**Sub:- Development of Assam State Zoo cum Botanical Garden,
Guwahati.**

The design of the proposed construction of different enclosures in the Assam State Zoo cum Botanical Garden, Guwahati or the development of the zoo were scrutinized by the Expert Group on Zoo Designing of the Central Zoo Authority in its meeting held on 21st November, 2008. The observations made by the Expert Group Members are reproduced below:-

PROPOSED PROJECT OFFICE
 FOR CONSERVATION BREEDING PROGRAM
 ASSAM STATE ZOO
 GUWAHATI

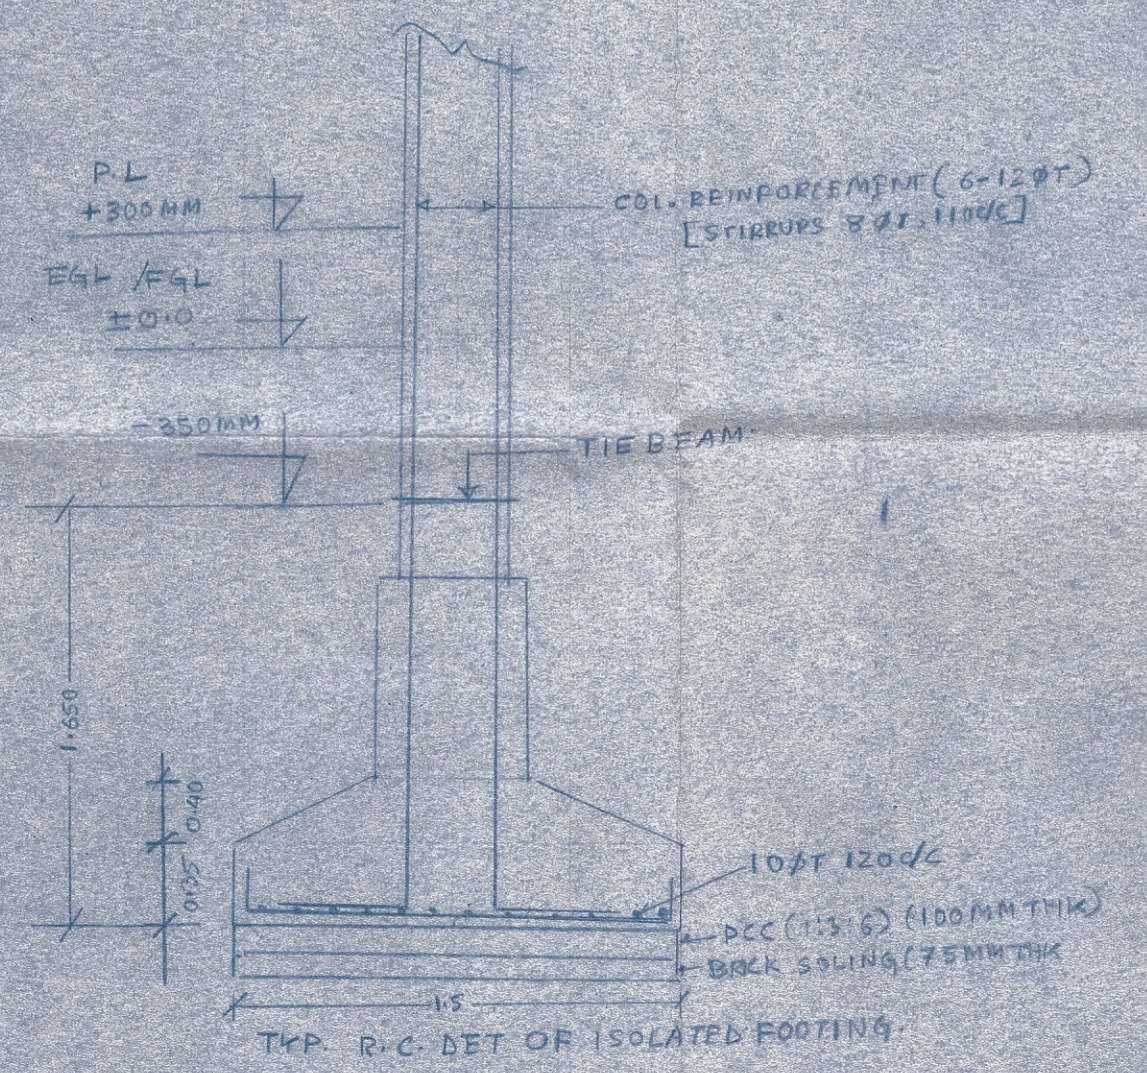
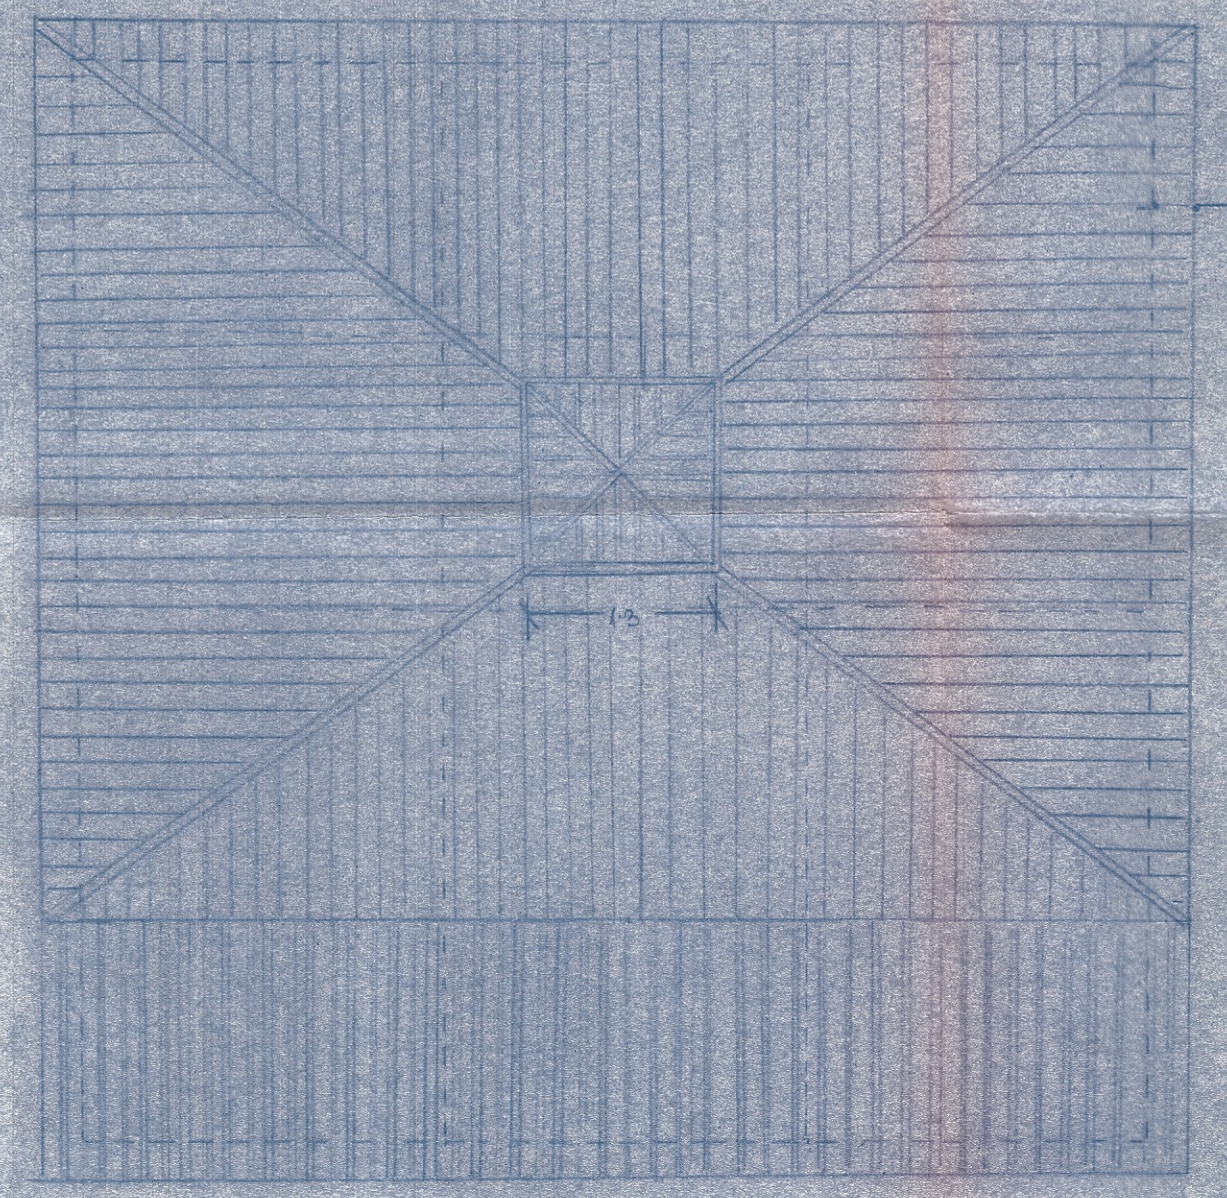
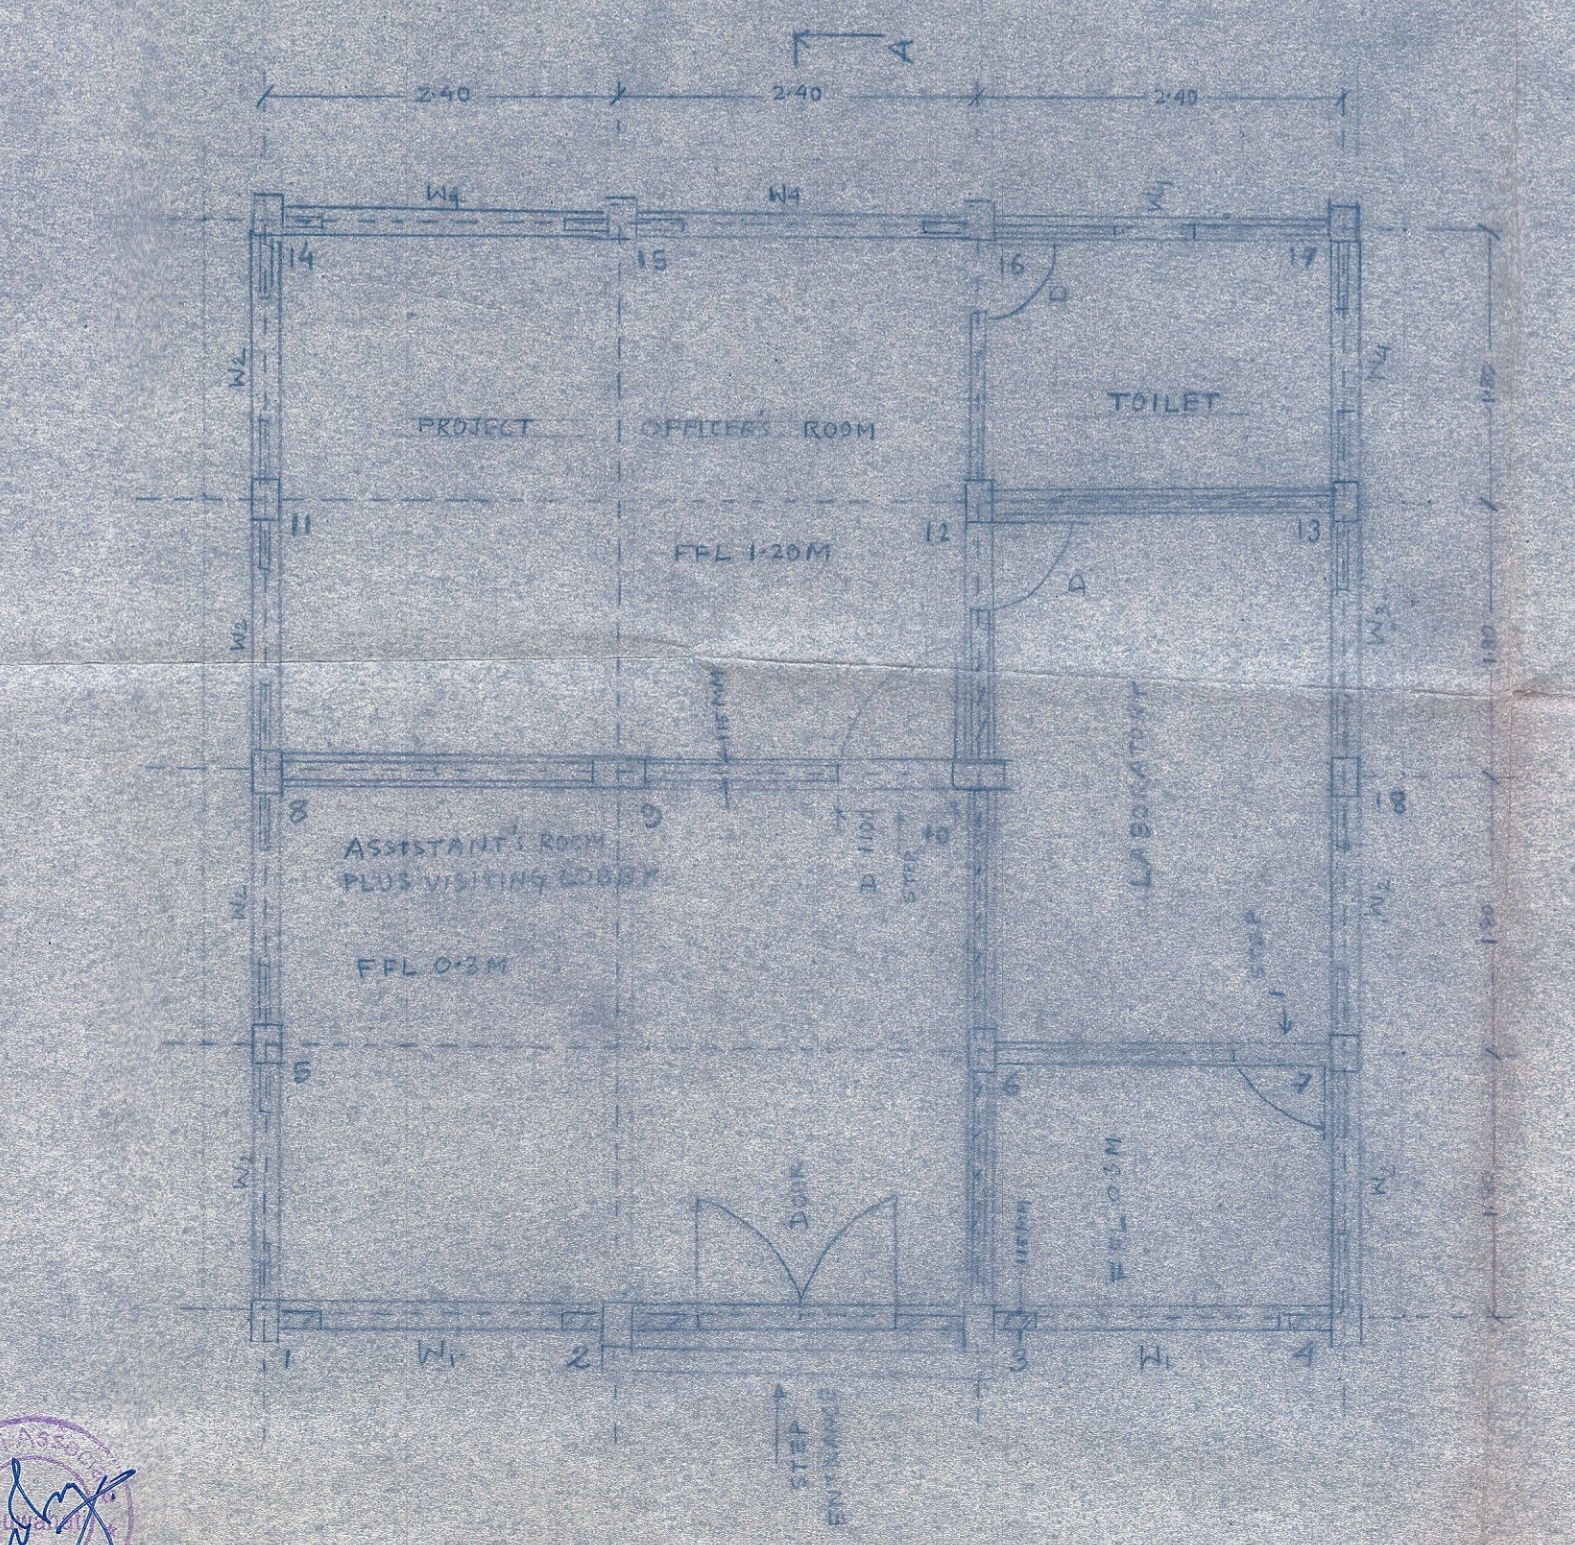
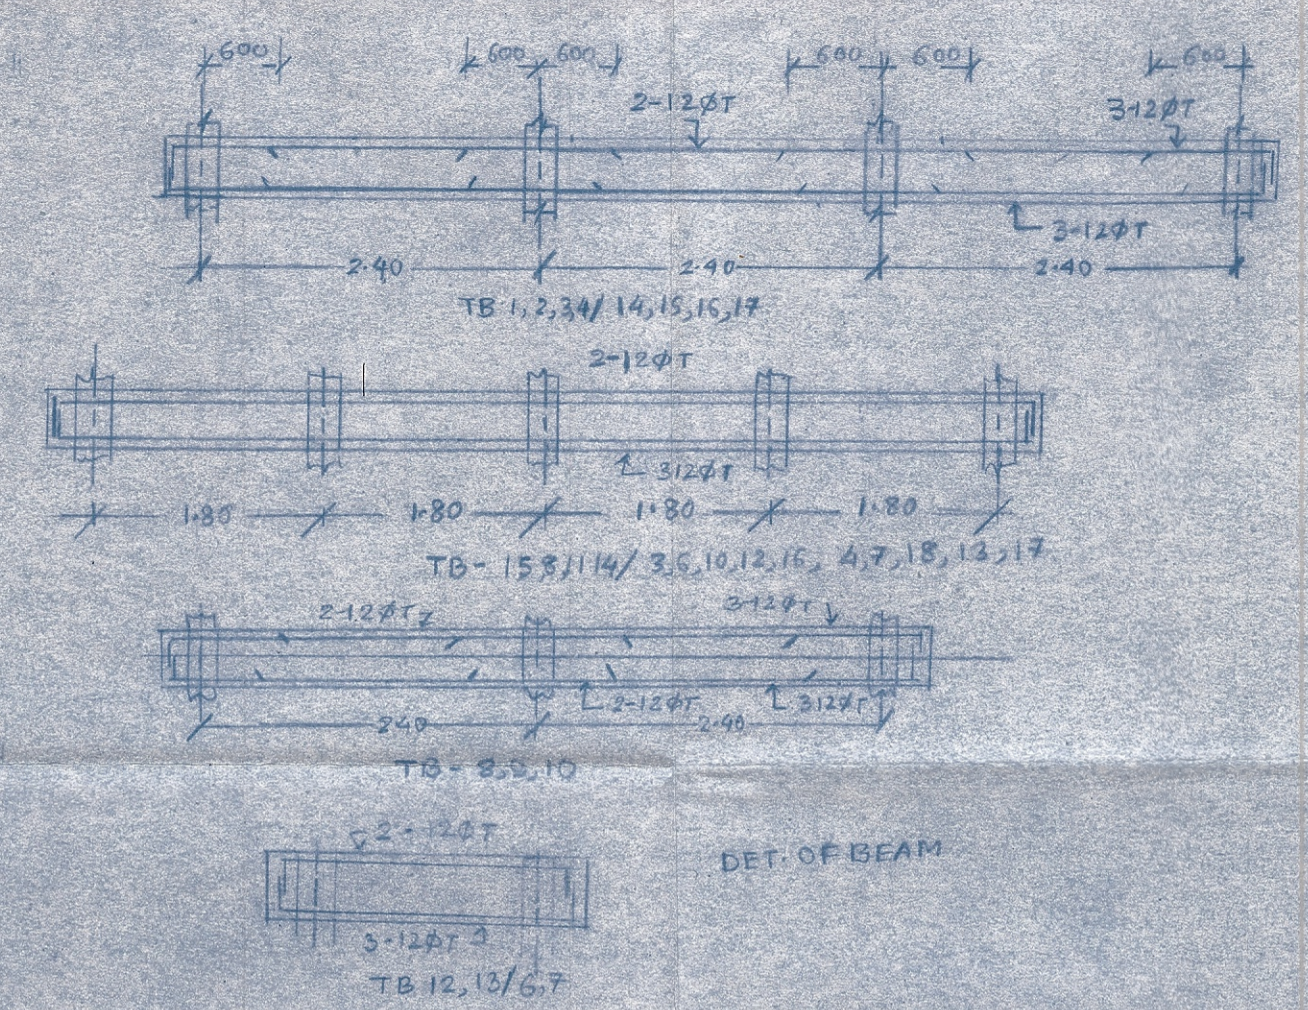
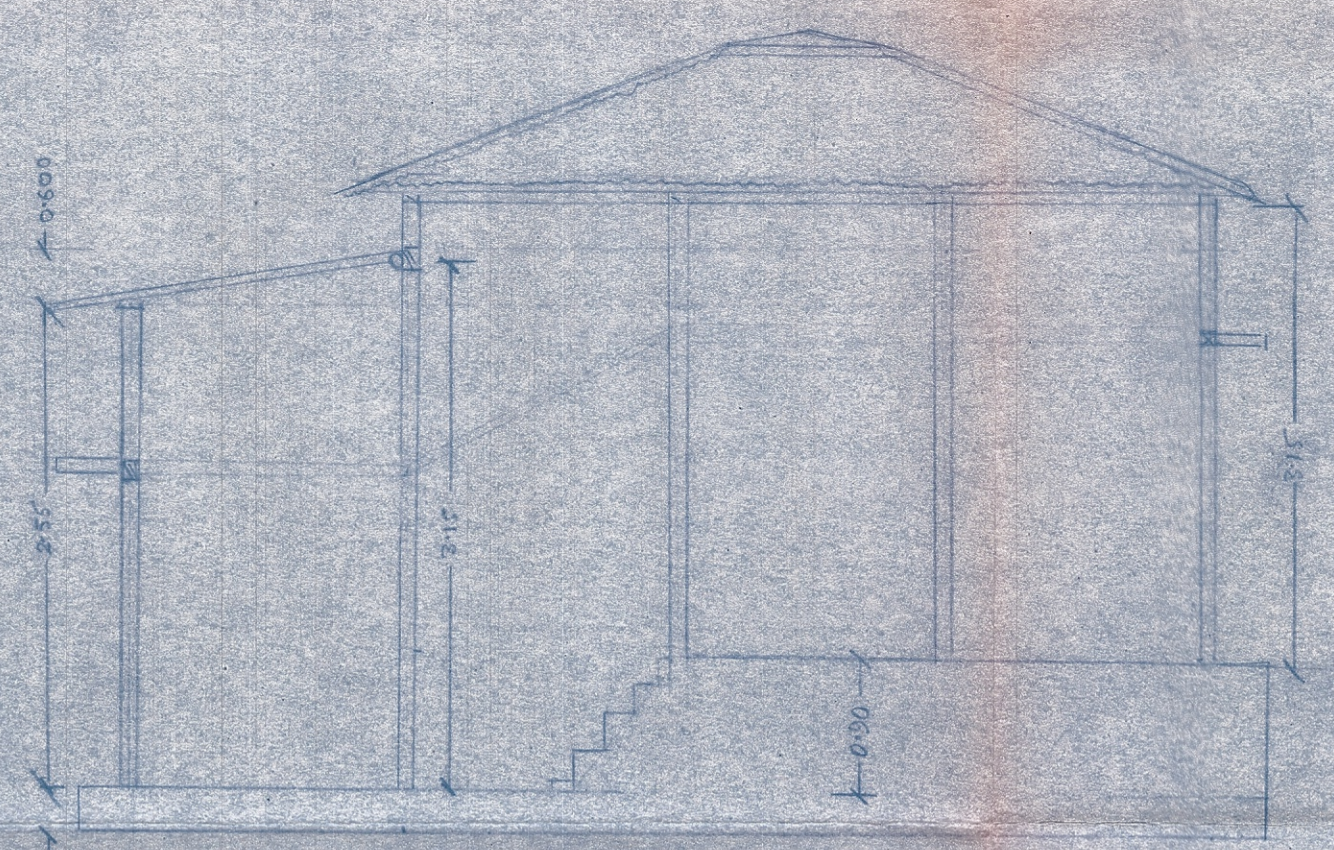
The design was approved subject to that the following amendments should be carried out and revised design should be submitted for the records of the Central Zoo Authority:-

- (a) The plinth area (covered area) in the project office should be limited to 50 sq. meter with 2 multipurpose room and one toilet.
(b) The cost of the construction should not exceed more than Rs. 7.5 lakhs.
